# Planning Report

## Ballantrae Woods PUD

15-119FDP/FP  
Final Development Plan/ Final Plat  
Ballantrae Woods PUD  
Cosgray Road

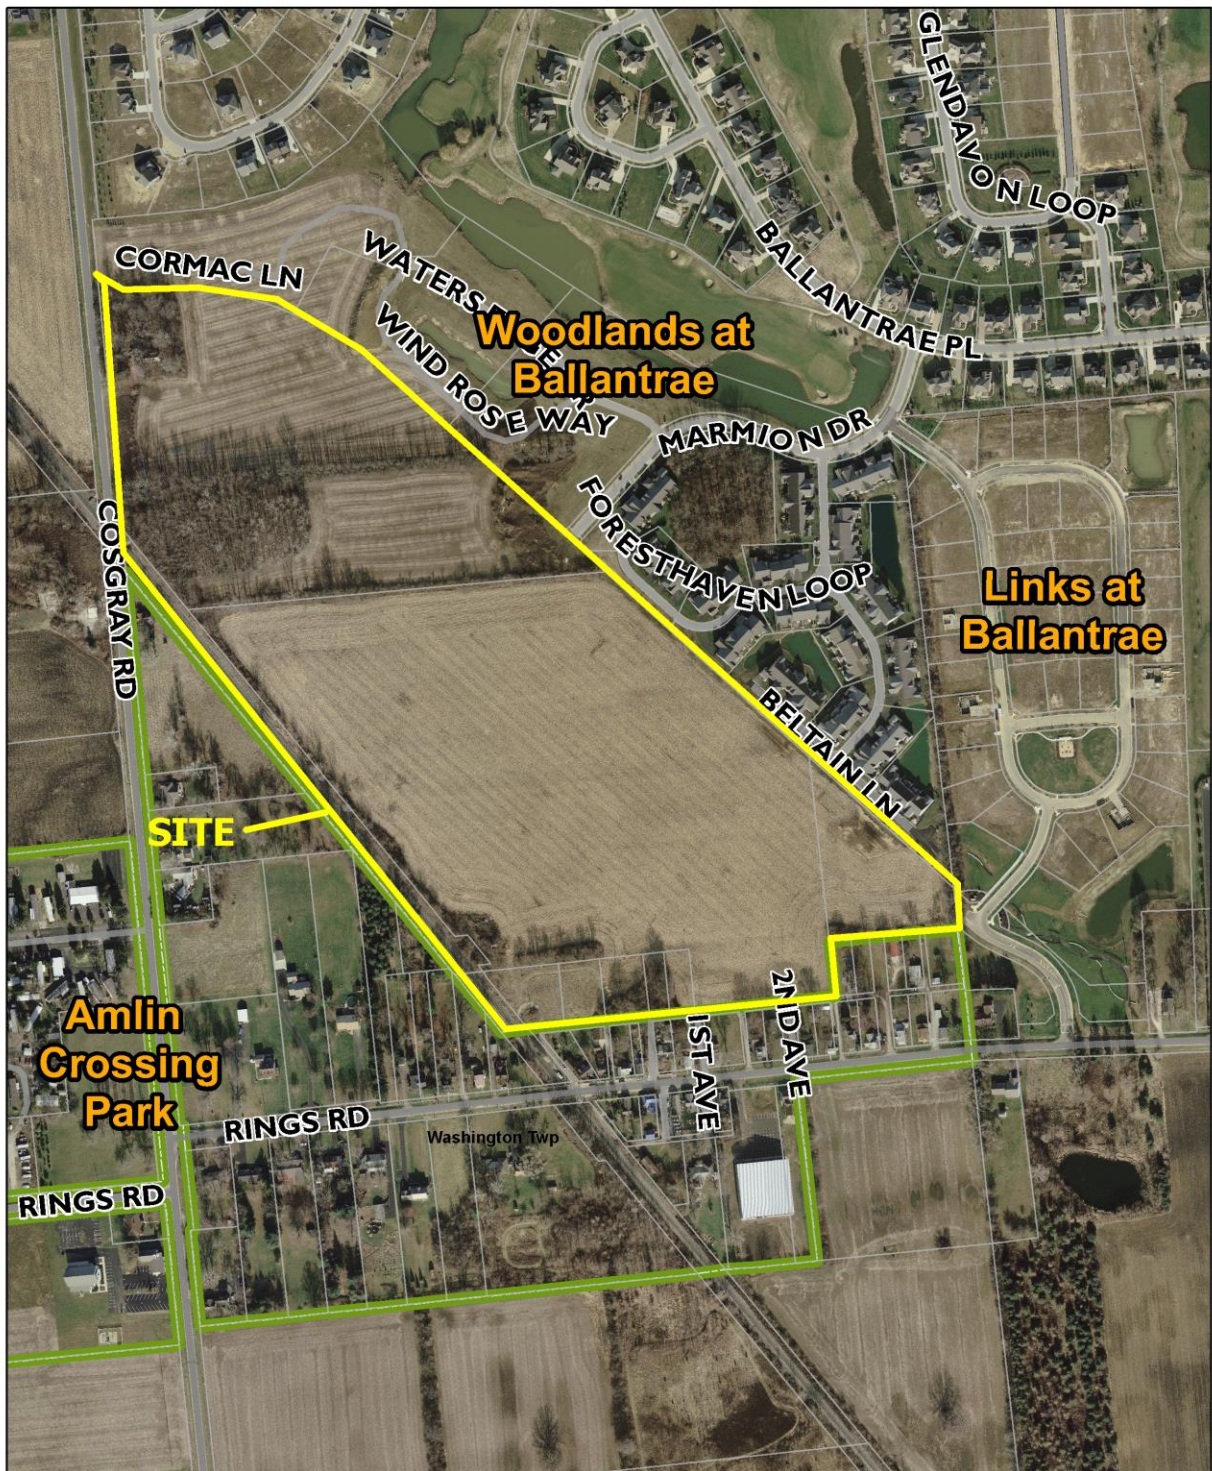
- 2) That the applicant modify the side elevations for the condominium units to introduce additional design elements to avoid large blank surfaces and achieve four-sided architecture;
- 3) That the applicant enter into an infrastructure agreement with the City of Dublin to address the fee to be paid for off-site traffic impacts, prior to the recording of a plat for any portion of the site, to the satisfaction of the City Engineer;
- 4) That the applicant resolves discrepancies between the summary table, final plat, and development text for open space reserves and area numbers prior to City Council review for final plat; and,
- 5) That the applicant work with staff in all areas that require disturbances in the reserve areas to locate the amenities in the least impactful manner.

<b>Details and Analysis</b>	
	<b>Minor Text Modification</b>
Proposal	Code Section 153.053(E)(2)(b)4 b permits the Commission to approve a modification to the development text and Zoning Code if they determine all appropriate provisions are satisfied.
Request	<p>The applicant has provided eight additional design elements, 3 dormer types and 5 window styles. These design elements will require a development text modification to be included in the text.</p> <p>The approved text requires that window styles must be single-hung with a grid pattern of either 4/4, 6/6 or 9/9. The applicant would like to expand this option to include a fixed window pane with a minimum of 2 grids creating a minimum of 3 faux lights.</p> <p>The additional dormer styles include one windowed dormer and two dormers with dot motifs (one roof dormer and one porch dormer).</p> <p>Planning is concerned that the large window addition and the two closed dormers</p>

Details and Analysis	Minor Text Modification
	<p>do not successfully integrate into the architectural theme of "Carpenter Gothic".</p> <p>The other proposed window modification provides consistency between approved design elements and the development text while providing flexibility for additional design elements for windows, and allows the residential units to have natural light in smaller areas of the home.</p>

Recommendation	Minor Text Modification
Approval with conditions	<p>Planning supports the minor text modification to permit the additional window and dormer styles except the large 9-square window and dot-motif dormers. The development text will be modified to include additional architectural window and dormer options with the exceptions shown outlined in red.</p>
